From: "Lindgren, Donald A." <lindg1da@westinghouse.com>
To: "jnw@nrc.gov" <jnw@nrc.gov>, 'Lauren Quinones' <LNQ@nrc.gov>
Date: Tue, Nov 1, 2005 4:47 PM
Subject: AP1000 Fire Protection System Line Numbers

PROPOSED REVISION 15
AP1000 DESIGN CONTROL DOCUMENT

Tier 1 Tables 2.3.4-2 and 2.3.4-4; and Tier 2 Figure 9.5.1-1

Fire Protection System

Figure 9.5.1-1 (Sheet 3 of 3)

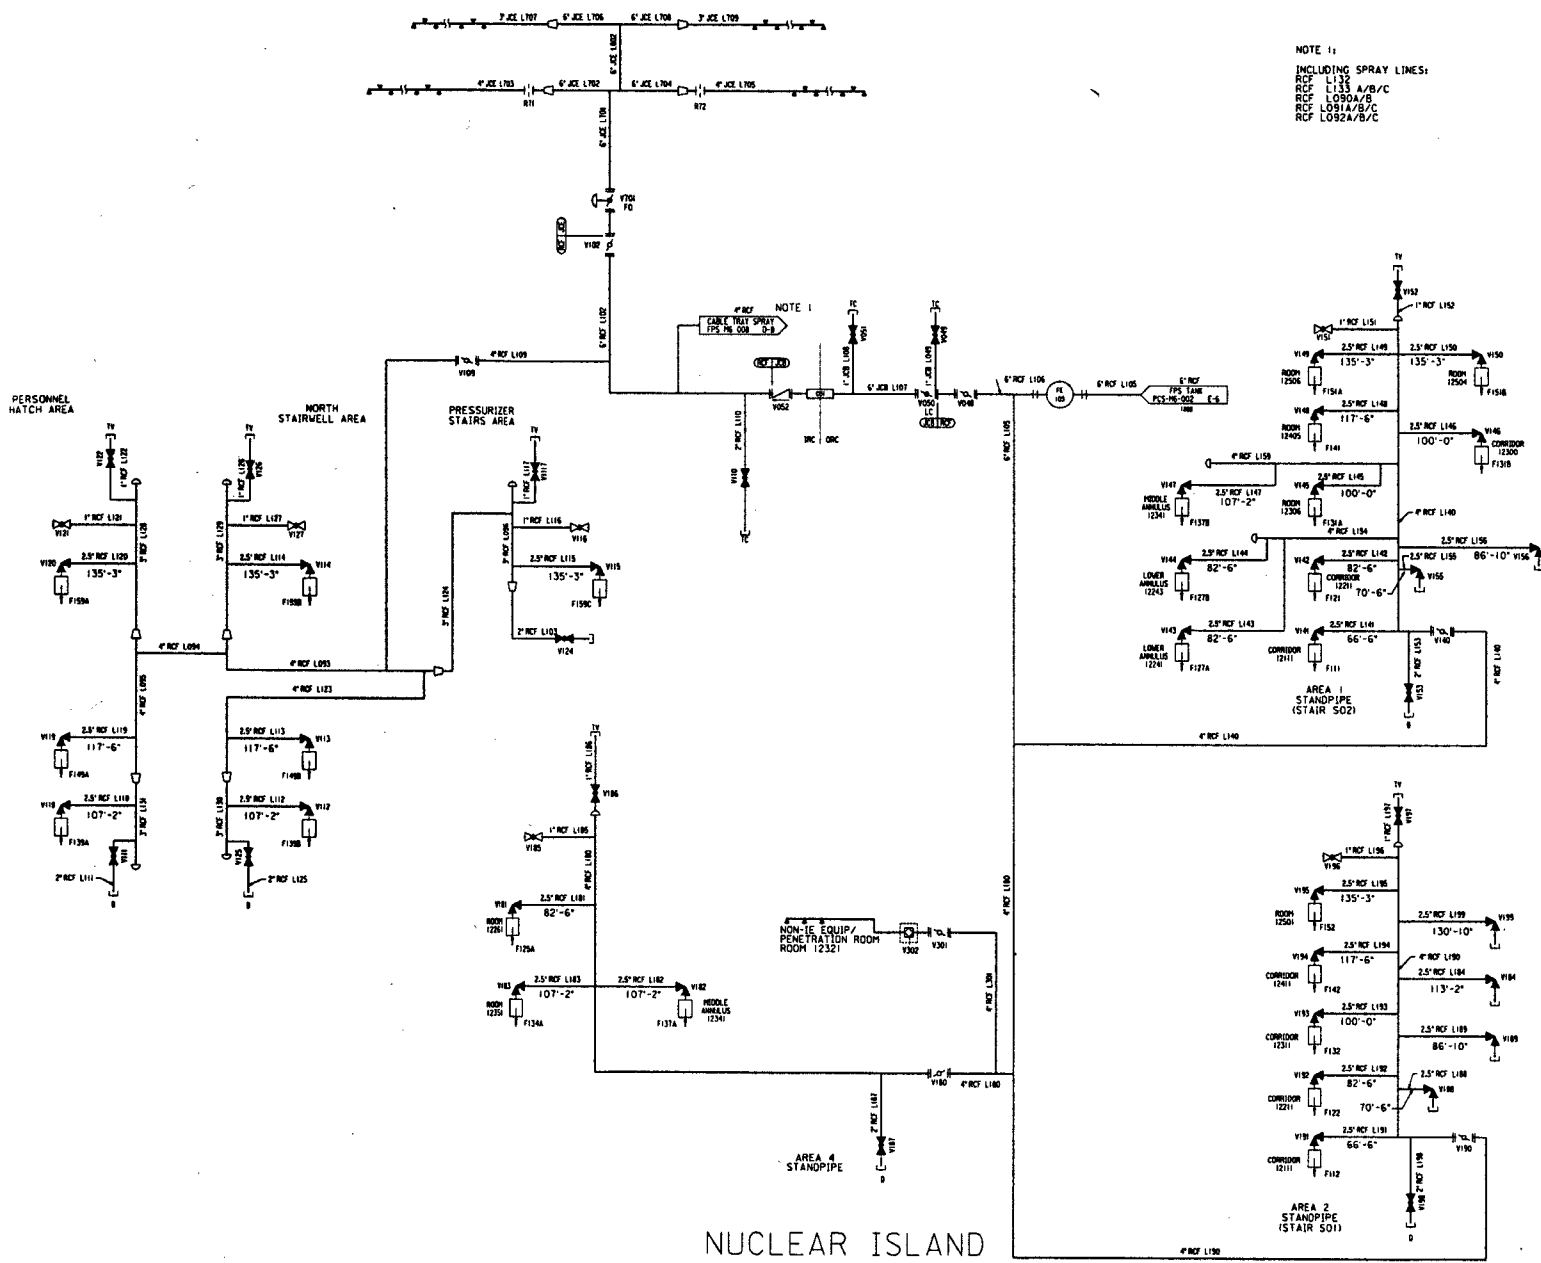
Provide precise references for ITAAC item 3 in Tier 1 Table 2.3.4-2. Revise the list of fire protection system piping that must remain functional following a safe shutdown earthquake. Revise Tier 2 Figure 9.5.1-1 to show line numbers.

Tier 2 Figure 9.5.1-1 (Sheet 3 of 3) Revise Tier 2 Figure 9.5.1-1 (Sheet 3 of 3) to include line number as shown on second page following.
